Product Change Notification

Product Group: SFERNICE / Sept 30th 2019 / PCN-SF-237-2019 Rev 0

SFERNICE WIREWOUND RESISTORS New Enamel Qualification

Enamelled coating examples

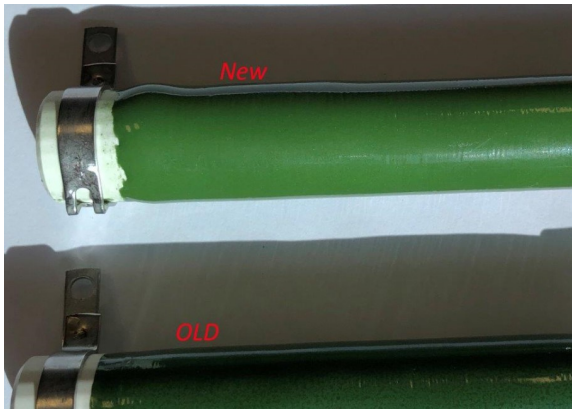
DESCRIPTION OF CHANGE: In line with our commitment for continuous improvement and procurement safety, Vishay Sfernice is adding a new qualified source for coating Enamel used on wirewound resistors. All products specifications remain unchanged.

New Enamel is ROHS compliant but will be fully Lead Free while current Enamel is ROHS compliant using exemption 7(c) I. Color remains the same see pictures in page 2.
